DEVELOPMENT NO.:	24025197
APPLICANT:	Thomas Treloar
ADDRESS:	18 GULF PDE SOUTH BRIGHTON SA 5048
NATURE OF DEVELOPMENT:	Appeal Report - Two (2) double storey detached dwellings with rooftop terraces, retaining walls up to 1.4m high and swimming pools
ZONING INFORMATION:	Zones: <ul style="list-style-type: none"> • General Neighbourhood Overlays: <ul style="list-style-type: none"> • Airport Building Heights (Regulated) • Affordable Housing • Prescribed Wells Area • Regulated and Significant Tree • Stormwater Management • Urban Tree Canopy
LODGEMENT DATE:	27 Aug 2024
RELEVANT AUTHORITY:	Assessment panel at City of Holdfast Bay
PLANNING & DESIGN CODE VERSION:	P&D Code (in effect) Version 2024.15 15/8/2024
CATEGORY OF DEVELOPMENT:	Code Assessed - Performance Assessed
NOTIFICATION:	Yes
RECOMMENDING OFFICER:	Alexander Stamatopoulos Development Officer - Planning
REFERRALS STATUTORY:	Nil
REFERRALS NON-STATUTORY:	Nil

Since the refusal was issued an appeal was lodged to the ERD Court to seek a compromise. The applicant has provided amended plans to address the reasons for refusal.

Plan Amendments

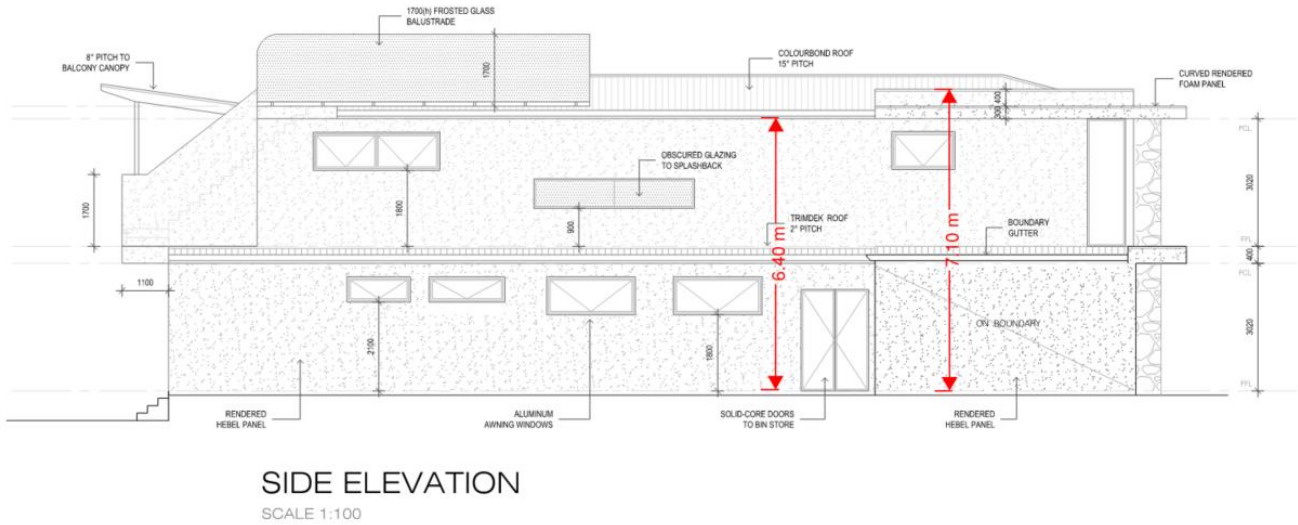
Balustrade Material Change: Replaced rooftop terrace balustrade with lightweight, obscured glass.

Rooftop Features Removed: Eliminated rooftop spa.

Balcony Roof Adjustment: Pitched the balcony roof to prevent downward views from the rooftop terrace.

Balustrade Height Increase:

- Balcony balustrade raised from 1.2m to 1.5m.
- Rooftop balustrade raised from 1m to 1.5m.

Privacy Screens Added:

- 1.7m high privacy screen at the top of the rooftop stairs for the southern dwelling.
- 1.7m solid wall on the southern side balcony and 1m solid wall at the bottom of the balcony stairs.

Building Shifted North: Increased 100mm setback from the Southern boundary.

Height Adjustments: Wall heights amended where its highest point is 7.1m to the front of the dwelling.

Above: Amended plans showing side wall heights
Below: Initial plans

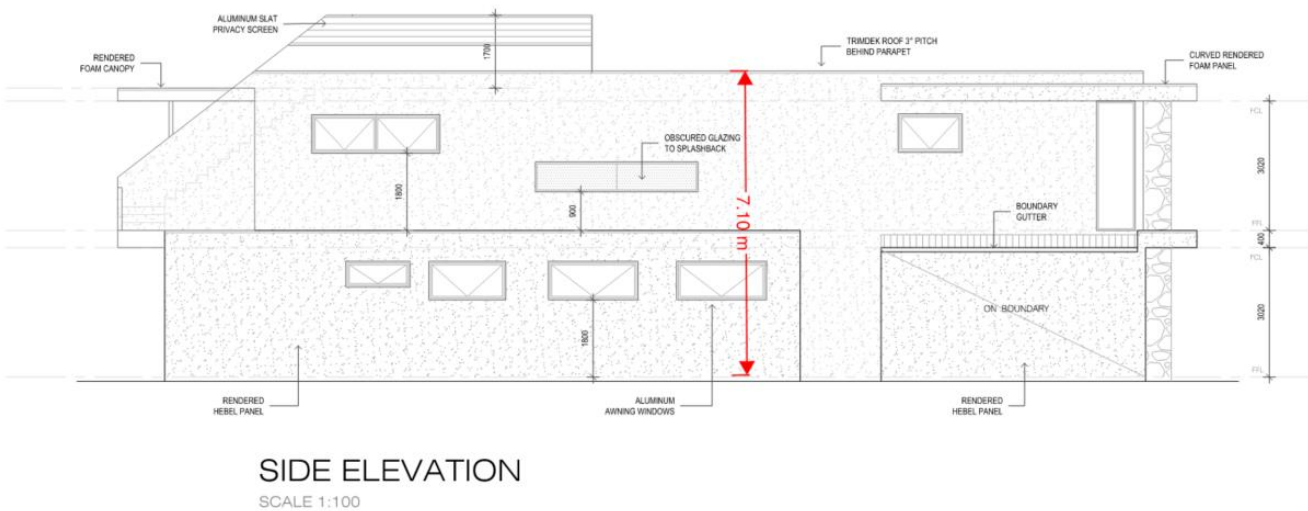
The initial refusal cited concerns that the proposed development did not align with the intended low-rise suburban character of the General Neighbourhood Zone (GNZ), due to excessive wall height and rooftop terrace elements. The original design featured a 7.1m high main wall and a rooftop terrace reaching 8.4m, leading to an increased perception of bulk and scale inconsistent with the zone's expectations.

In response, several amendments have been made to reduce the perceived and actual building bulk. Most significantly, the majority of the side walls have been reduced from 6.4m, bringing the development within a scale more reflective of low-rise suburban character. Additionally, the replacement of the rooftop balustrade with lightweight, obscured glass ensures that the development remains visually unobtrusive from key vantage points.

The General Neighbourhood Zone anticipates and accommodates two-storey dwellings, with an upper wall height of up to 7m. The revised proposal is now below this threshold, ensuring a built form that does not dominate the streetscape or adjacent properties. Given the reduction in scale the amended proposal now satisfies PO 4.1, ensuring that the development contributes appropriately to a low-rise suburban character.

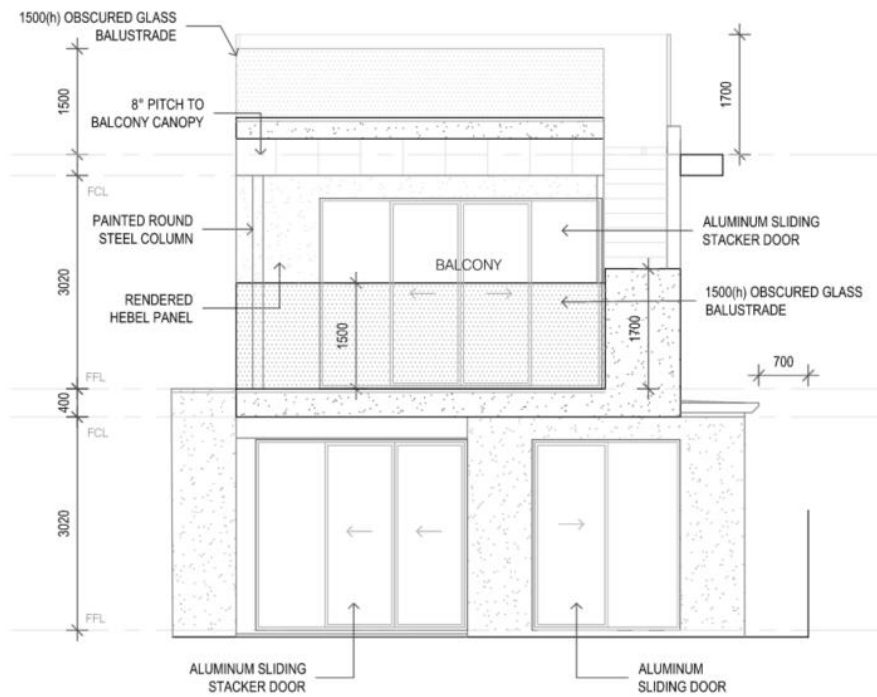
The initial refusal identified concerns regarding side boundary setbacks, specifically that the proposed upper-level and rooftop setbacks did not meet the DPF 8.1 guidelines, thereby reducing separation between dwellings and potentially impacting natural light and ventilation for adjacent properties.

.In response, the amended plans have increased the setback from the southern boundary by shifting both dwellings 100mm north. While the revised upper-level and rooftop setbacks still fall below the quantitative targets of DPF 8.1, it is critical to assess the actual impact of the development, particularly in relation to overshadowing and spatial separation.

An overshadowing analysis provided with the initial plans comparing the proposed design to a compliant 2.9m upper-level setback demonstrated that the difference in shadowing impact is negligible throughout the day. At 9:00 AM, the shadowing from both the proposed and compliant setback scenarios extends towards the adjacent north-facing habitable room windows, with minimal variance. At 12:00 PM, when the sun is at its highest point, both designs exhibit similar shadowing effects on the lower level of the neighbouring property. At 3:00 PM, the afternoon shadows extend further east, with only a minor difference between the two scenarios.

The overshadowing diagrams confirmed that even a fully compliant two-storey detached dwelling with a 2.9m setback would result in overshadowing of the neighbouring southern property. Given that the General Neighbourhood Zone anticipates two-storey dwellings, some level of overshadowing is expected and unavoidable. The side setback separation is consistent with the recent construction that along Gulf Parade therefore it is not an odd with the suburban character.

The amendments provide an increased degree of separation, while ensuring overshadowing impacts remain consistent with a compliant two-storey dwelling. As such, the amended design satisfies the intent of PO 8.1, as it provides sufficient building separation while maintaining adequate natural light and ventilation for adjacent dwellings.

Above: Amended rear elevation (Dwelling 1)

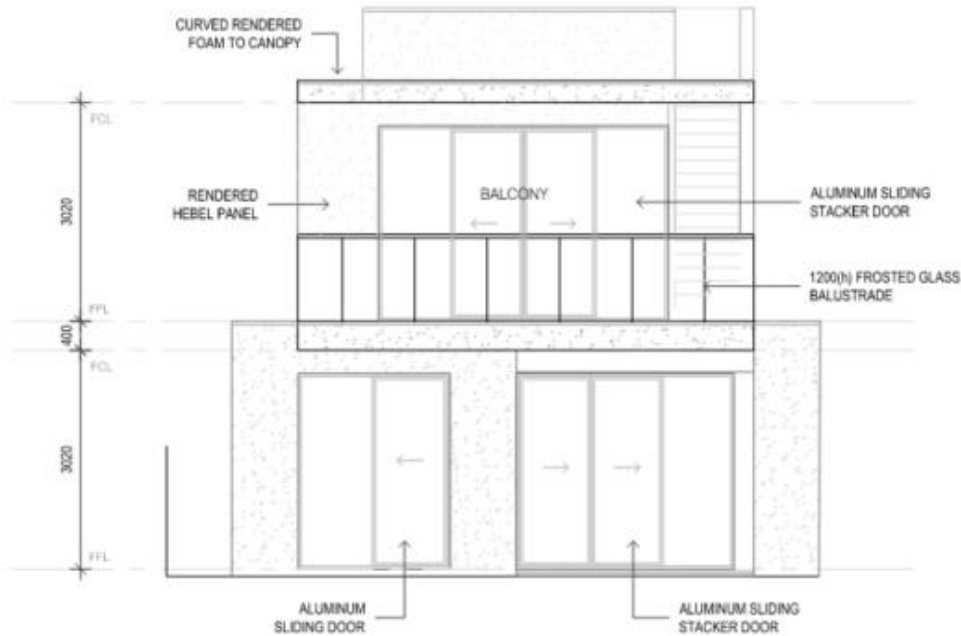
The original proposal raised concerns regarding overlooking and direct sightlines into adjacent properties, particularly from the balconies and rooftop terraces. Representors identified that the initial 1.2m-high balustrades on the balconies and the lack of sufficient rooftop screening allowed for direct views into private open space and habitable rooms, notably at 181 Esplanade, 180 Esplanade, and 20 Gulf Parade.

To address these concerns, modifications have been made to the balustrade heights and screening elements. The balcony balustrades have been increased from 1.2m to 1.5m, thereby blocking lower sightlines into adjacent properties. Similarly, the rooftop balustrades have been increased from 1m to 1.5m, reducing potential overlooking impacts. Additional privacy measures include the introduction of a 1.7m-high privacy screen at the rooftop stair entry and a 1.7m solid wall on the southern side balcony to dwelling 1, as well as a 1m solid wall at the bottom of the balcony stairs, which collectively ensure that sightlines into neighbouring private spaces are effectively obstructed.

The amendments align with the performance intent of PO 10.2, ensuring that views from elevated areas are directed away from habitable spaces and private outdoor areas. The increased screening and balustrade heights eliminate the potential for intrusive overlooking, bringing the development into full compliance with PO 10.2.
